Welch Allyn, Inc. 4341 State Street Road Skaneateles Falls, NY 13153 USA	URGENT: Field Safety Notice	2021-07-001-MKE-005
---	------------------------------------	---------------------

ELI280, MLBUR280 and BUR280 Electrocardiographs

ELI280 resting electrocardiograph - Patient mismatch/Software Upgrade

FSCA-identifier: 2021-07-001-MKE-005

Figure.1

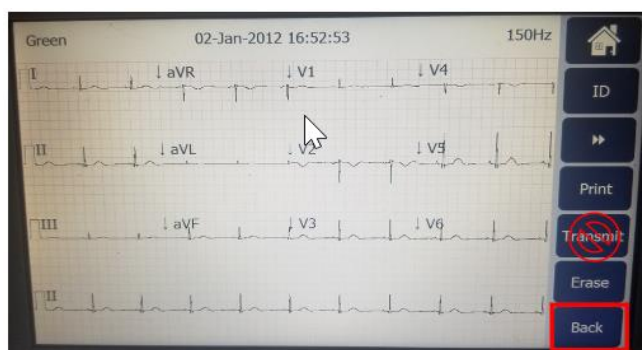
1. An ECG is acquired for Patient A and stored to the cardiograph.
2. An ECG is acquired for Patient B and stored to the cardiograph.
3. The ECG record associated with Patient A is retrieved from memory and any Patient Demographic information is edited.
4. After editing, the "Resting ECG" screen is presented as shown below. Figure 1
5. Pressing the TRANSMIT button from this screen (following any Patient Demographic edit) will transmit an ECG record other than for patient A. (see figure 2, which shows the Resting ECG screen).

If an ECG record is retrieved from the patient directory for a Patient Demographic edit to be performed, once the information has been edited and the screen above (Fig 1) is presented, do not press the transmit button. Instead, press the BACK button which will SAVE the changes to memory and present the user with the following screen, where the SYNC button can be used to transmit the desired record to the configured destination.

Figure.3

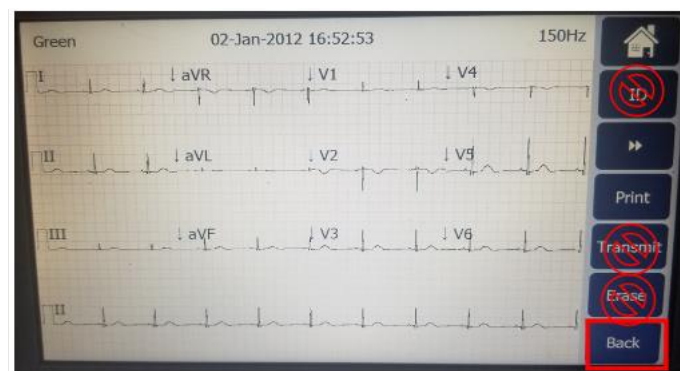
1. An ECG is acquired for Patient A and stored to the cardiograph.
2. An ECG is acquired for Patient B and stored to the cardiograph.
3. The ECG record associated with Patient A is retrieved from memory and ID information is edited.
4. After editing, the “Resting ECG” screen is presented as shown in Figure 3.
5. The user decides to make another ID Edit without leaving the “Resting ECG” screen and presses the “ID” button - Figure 3.

6. After the second edit is performed, the “Resting ECG” screen is once again presented as shown above.
7. Pressing the TRANSMIT button from this screen (following two ID edits in a row as defined above) will transmit an ECG record with the patient demographics
